# UNITED STATES PATENT AND TRADEMARK OFFICE

APPLICATION NO.	FILING DATE	FIRST NAMED INVENTOR	ATTORNEY DOCKET NO.	CONFIRMATION NO.
09/940,949	08/28/2001	Luc Tripod	PU010180	5192

# Office Action Summary

## **DETAILED ACTION**

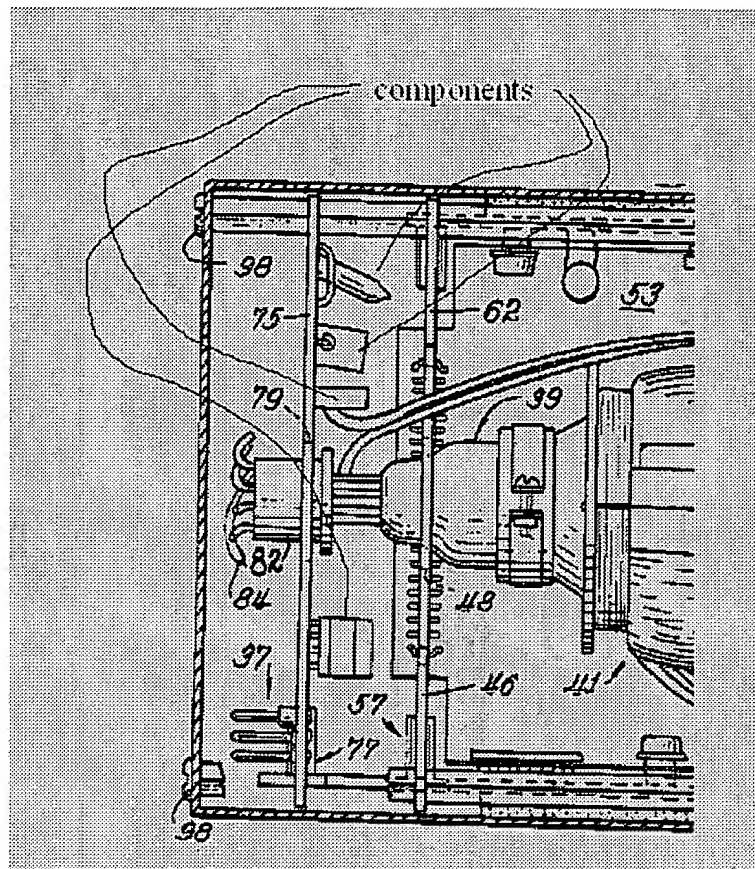
-- In reference to claims 2 and 8, Puhak shows substantially the invention as claimed. However, Puhak does not show the circuit board has a plurality of components mounted thereon, none of the components extending away from the funnel further than the back cover of the socket.

Johnson shows (cover sheet) the circuit board 75 has a four (a plurality) components (see examiner's figure) mounted thereon, none of the four components extending away from the funnel further than the back cover of the socket.

It would have been obvious to one of ordinary skill in the art at the time the invention was made to use the component configuration shown by Johnson on the circuit board of Puhak because, as shown by Johnson (cover sheet), if the components were mounted on the other side of the circuit board, it would not make it possible to use wire 86 to electrically connect at least one of the plurality of components to the funnel.

-- In reference to claim 3, Puhak as modified by Johnson shows (figure 8 ) the circuit board has a plurality of components (see examiner's figure) mounted on the first side.
